Application for Jackpine Mine Tailings Management Plan

May 23, 2018

Decision 20180523B: Canadian Natural Upgrading Limited; Application for Jackpine Mine
Tailings Management Plan

Figure 1. Legacy fluid tailings profile

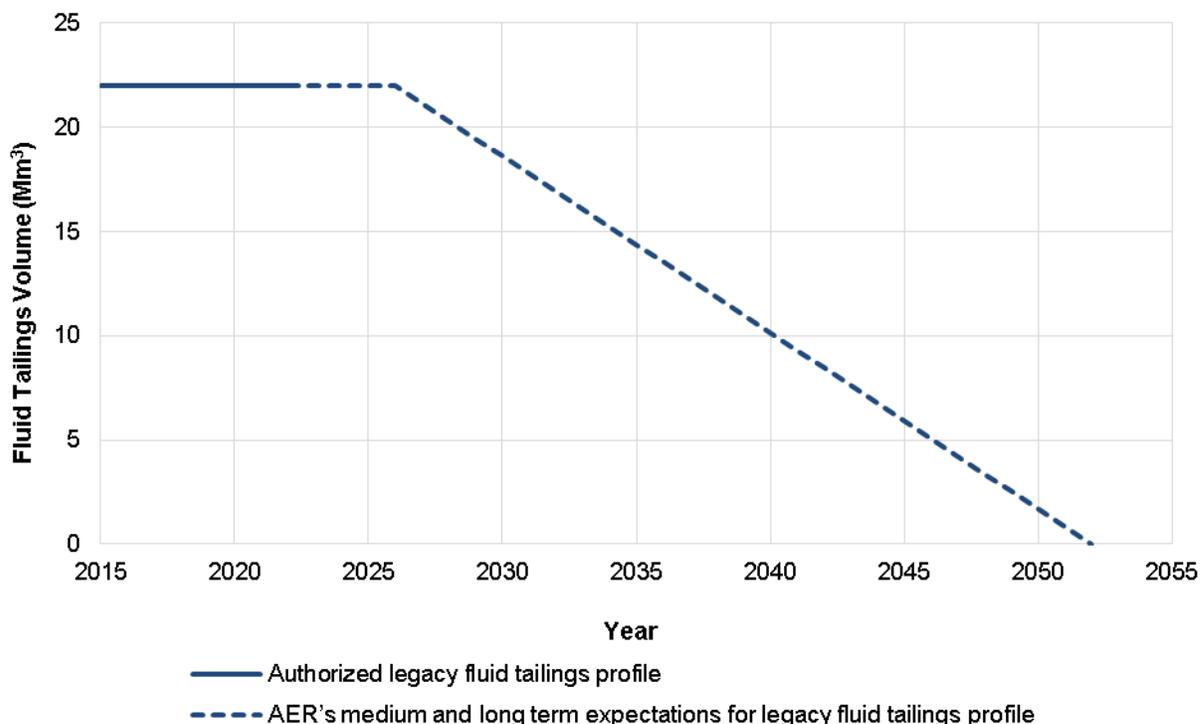
[38] CNUL's legacy fluid tailings profile is authorized until December 31, 2023, as shown in appendix B of the approval (appendix 1). The solid line in figure 1 below depicts the authorized legacy fluid tailings profile that CNUL is required to achieve until December 31, 2023. The dotted line in figure 1 depicts the AER's medium- and long-term expectations for the legacy fluid tailings profile.

[39] In the amendment application CNUL is required to provide a revised legacy fluid tailings profile that demonstrates that all legacy fluid tailings are RTR by the JPM's end of mine life and align with JPM's end of mine life (2052). At a minimum, the AER expects CNUL's amendment application to meet the legacy fluid tailings profile depicted in the dotted line in figure 1.

Figure 2. New Fluid Tailings Profile

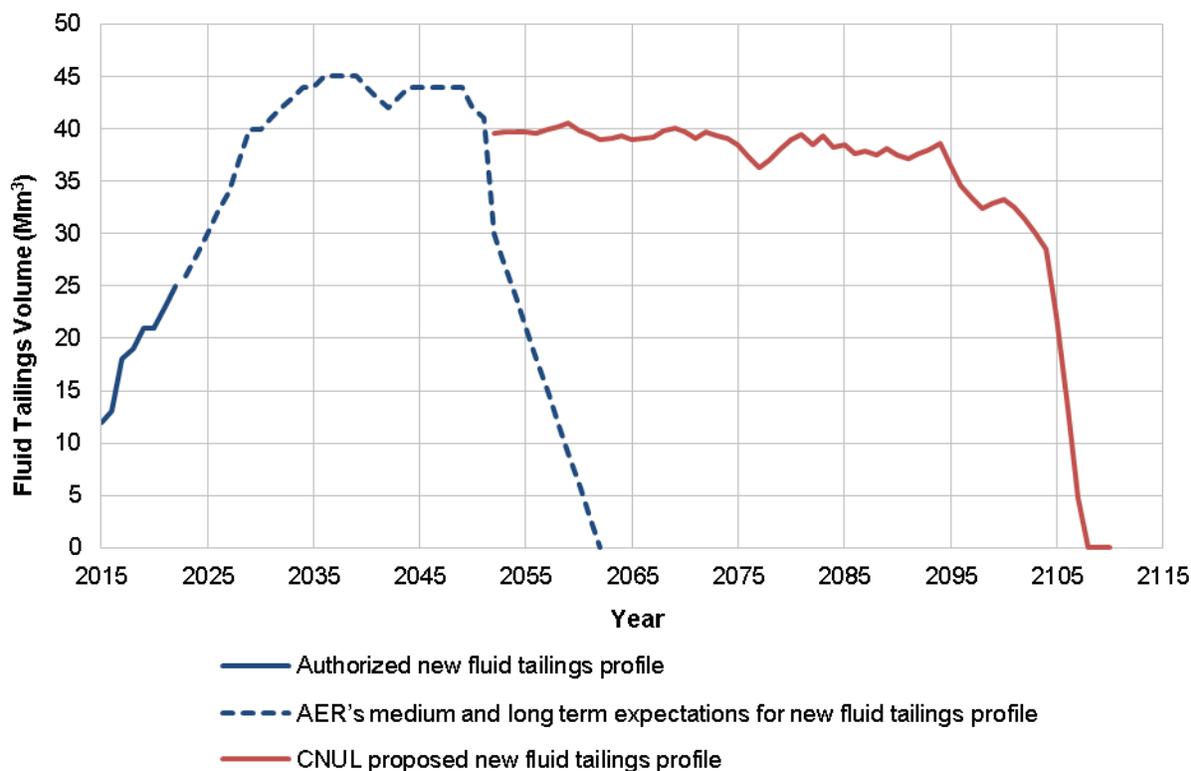
[42] CNUL's new fluid tailings profile meets the *TMF* and *Directive 085* profile guidance until December 31, 2023. CNUL's new fluid tailings profile is authorized until December 31, 2023, as shown in appendix B of the approval (appendix 1). As a result, no end of mine life target is authorized. The solid blue line in figure 2 below depicts the authorized new fluid tailings profile that CNUL is required to achieve until December 31, 2023. The dotted blue line in figure 2 depicts the AER's medium and long

term expectations for the new fluid tailings profile. The solid red line in figure 2 depicts CNUL's proposed new fluid tailings profile between 2053 and 2110.

[43] However, CNUL's proposed new fluid tailings profile beyond 2023 (see solid red line depicted in figure 2) does not meet the *TMF*'s objective or the *TMF* and *Directive 085* profile guidance:

[45] To address the concerns, in the amendment application CNUL is required to provide a revised new fluid tailings profile that:

[46] At a minimum, the AER expects CNUL's amendment application to meet the new fluid tailings profile depicted in the dotted line in figure 2.
